# Gunlake Quarry Continuation Project (SSD-12469087)

## Submissions Report

J190263 RP#24

Regional geological section A–A’  
 Gunlake Quarry Continuation Project Submissions Report  
 Figure 4.1

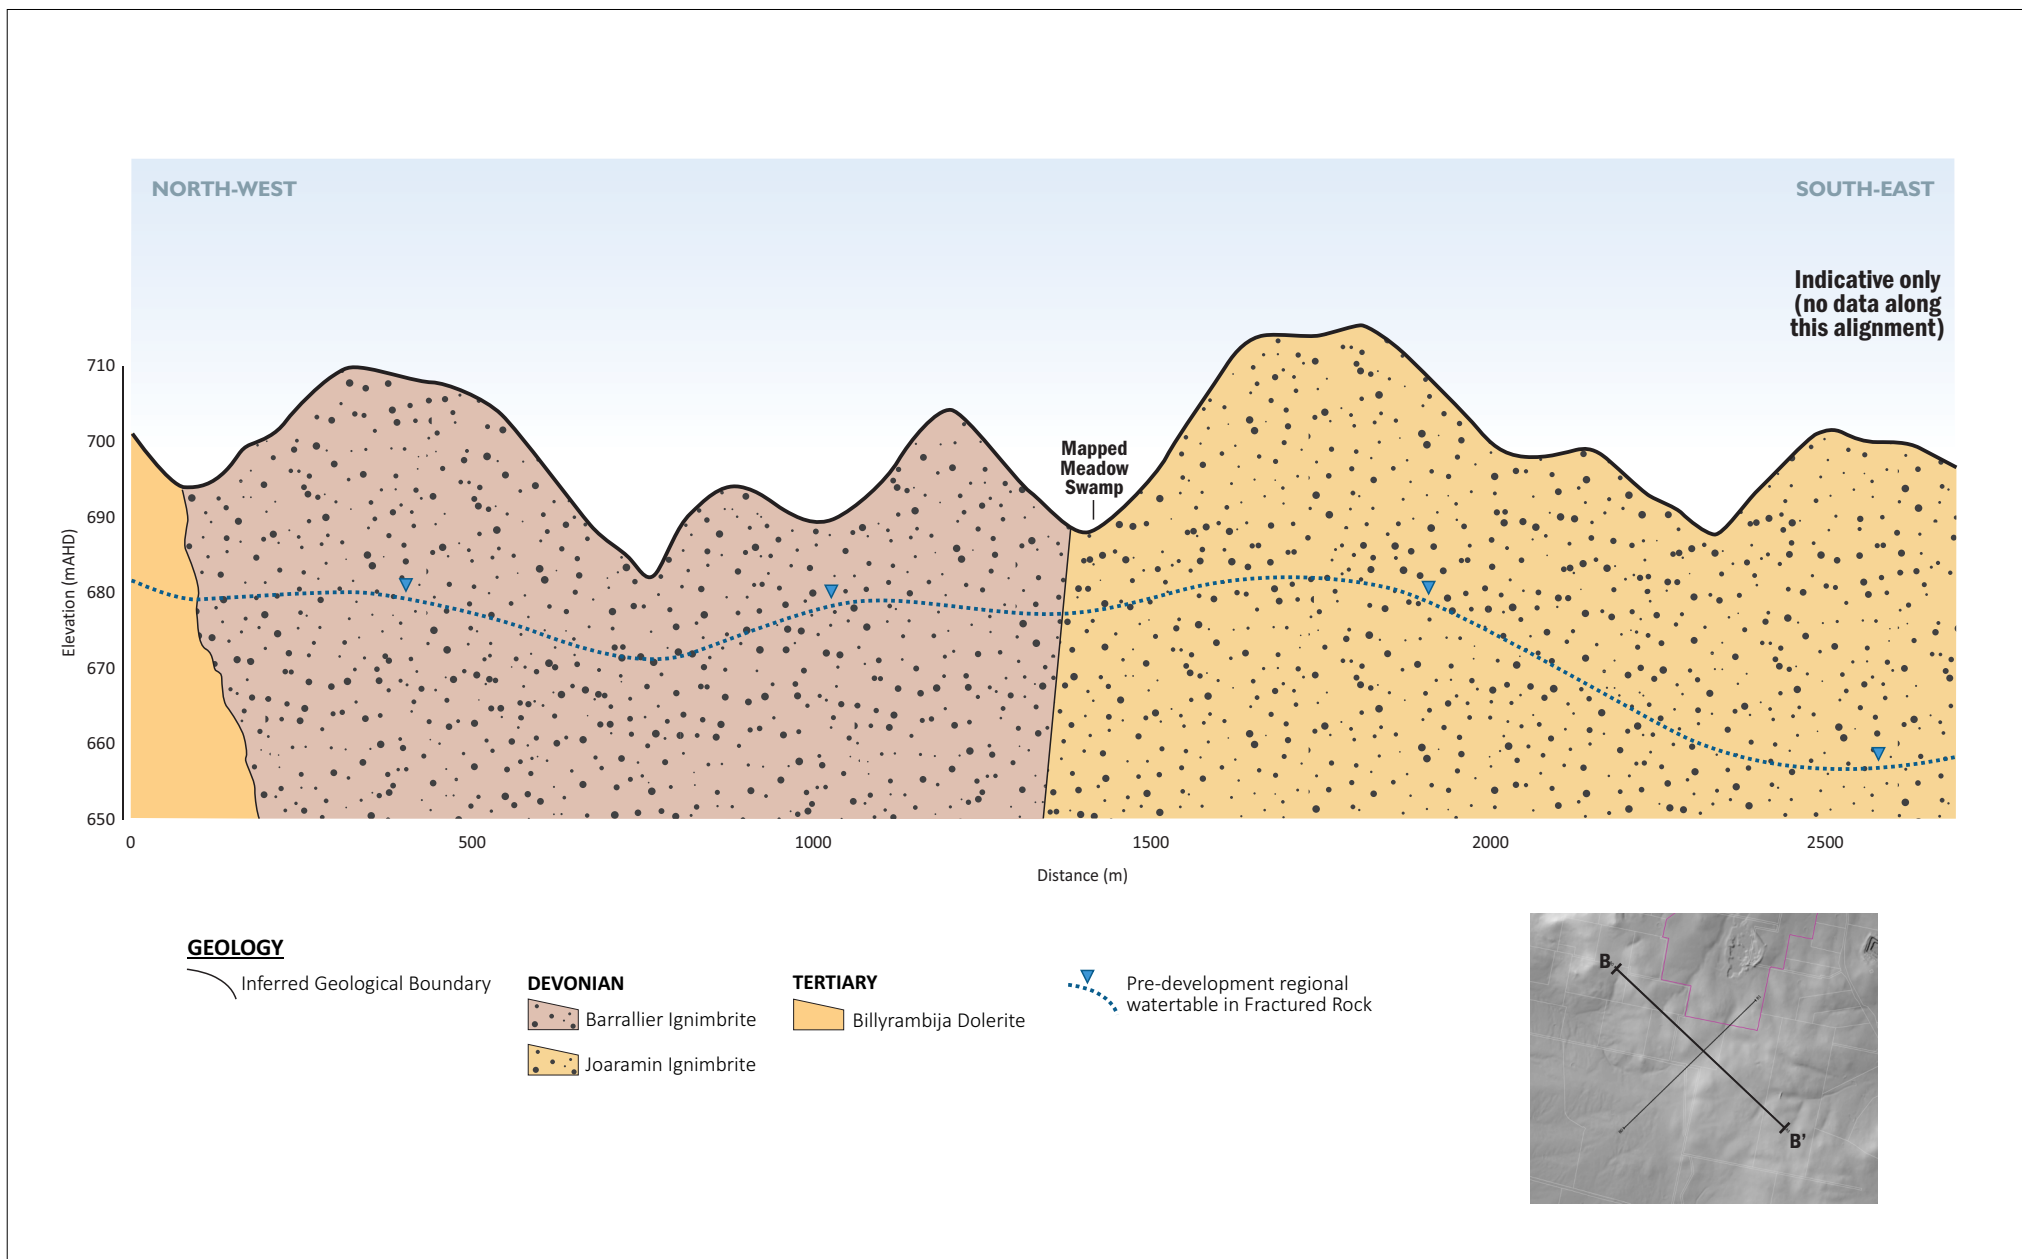
DPE Water noted that predicted cumulative groundwater impacts are based on an analytic element groundwater flow model and categorised in accordance with the Australian groundwater modelling guidelines as a class 1 flow model. The NSW Aquifer Interference Policy Section 3.2.3 states where a development consent under Part 4, Division 4.1 of the *Environmental Planning and Assessment Act 1979* applies, the proponent's impact assessment is to be based on complex modelling platform that is:

- The Continuation Project groundwater assessment should be revised to account for cumulative local impacts.
  - The proponent should provide clarification of the intention to obtain a new licence from unallocated water in the Groundwater Water Sharing Plan under the *Water Management Act 2000* that would enable continued extraction of 68 megalitres per year inflow at the end of the quarry's life.

Since the submittal of the EIS, a site inspection on 25 January 2022 by Nathan Garvey, EMM Principal Ecologist, and John Ross, EMM National Technical Leader – Groundwater, and review of groundwater data has confirmed the following.

- A perched water table exists in the alluvium/colluvium located along the primary gully located south of the quarry. This localised system is disconnected by tens of metres from the regional groundwater system in the fractured rock aquifer and consequently will be unaffected by any drawdown in the fractured rock aquifer. A revised conceptualisation of the regional and local groundwater systems is shown in Figure 4.1 (Section A-A' orientated south-west to north-east) and Figure 4.2 (Section B-B' orientated north-west to south-east).
- Seepages across the landscape and in exposed quarry faces are ephemeral and only occur after rain. They are indications of a small percentage of rainfall infiltrating to the regional water table, or discharging in the landscape as interflow. They will be unaffected by any drawdown in the fractured rock aquifer.

- No dykes are known within the quarry area. Dykes are most probably associated with the intrusion of the Lockyersleigh Granite located more than 1 km to the south-west and these dykes will have variable orientations, thicknesses and lengths. No dykes are shown on the published mapping for the area. Where present, the dykes weather to low-permeability clay horizons and are not conduits for regional groundwater flow. There is no justification for including them in any modelling as their distribution is unknown and they are unlikely to affect regional drawdown.

- Cumulative impacts between quarry operations are likely to be negligible given the different geologies and the low permeability of the fractured rock groundwater system. A revised appreciation of the pre-development water table and the indicative drawdown at the end of quarrying (for both the Holcim and Gunlake Quarries) in the fractured rock aquifer is provided in Figure 4.3 (section orientated south-west to north-east).

## Culvert widening concept drawing

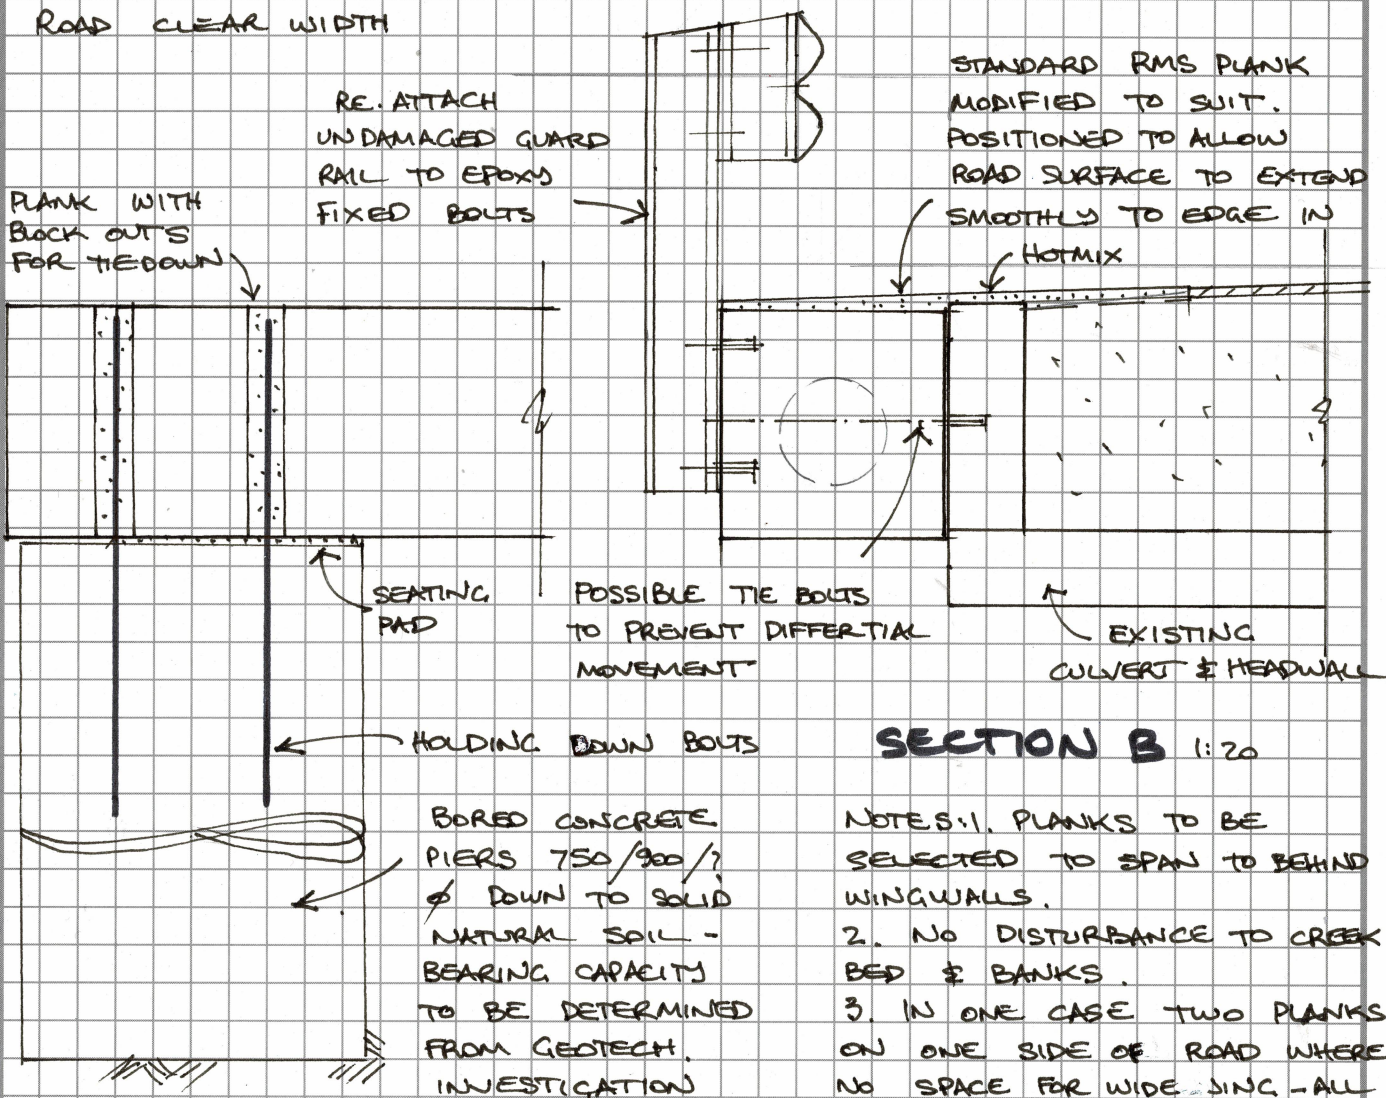
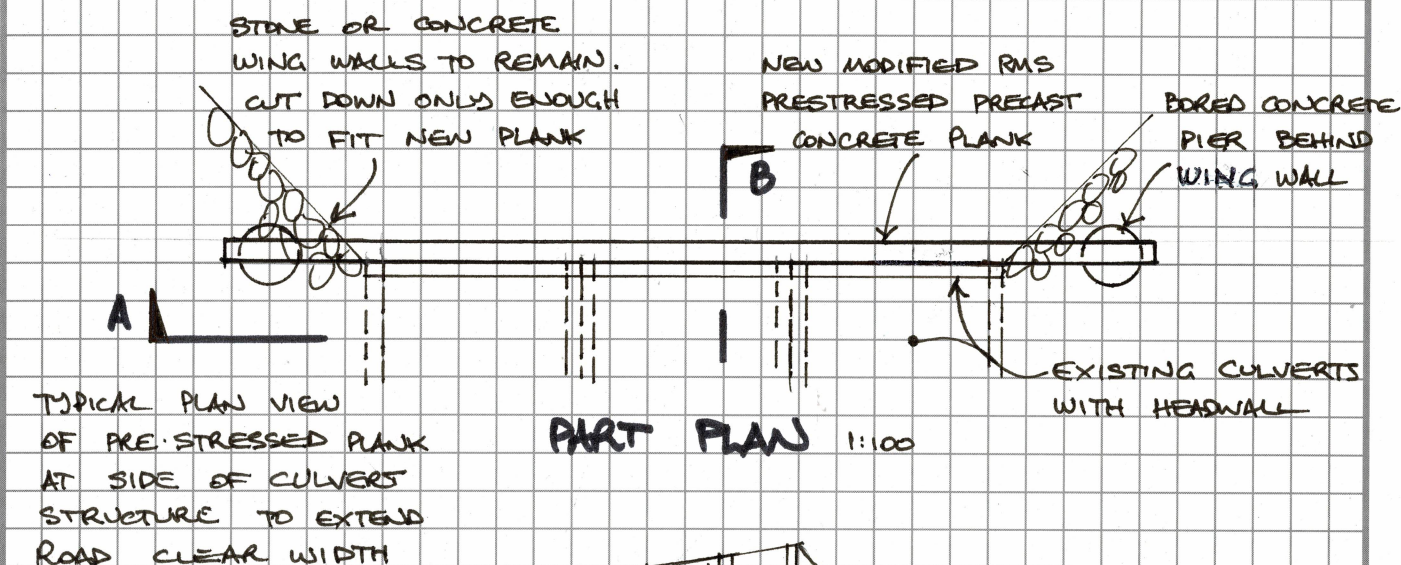
Council requested that a consistent wide centre line treatment (WCLT) be implemented along the Primary Transport Route. The EIS identified that the current road design on the Primary Transport Route exceeds the requirements of the Austroads guidelines. However, there are some narrower sections across major culverts where the WCLT is not provided. Gunlake propose to increase the road-width across five (Culverts A to E) of the six culverts along the Primary Transport Route (Figure 3.1).

As the WCLT is about 1-m wide, the pavement across these culverts will need to be widened by about 1.2 m. The widening will be achieved by extending the road surface across the top of the existing culverts using pre-stressed precast concrete slabs with the road safety barrier fixed to the outer slab. Installation of the slabs will not disturb the watercourse or banks. Conceptual culvert widening plans are provided in Appendix B.
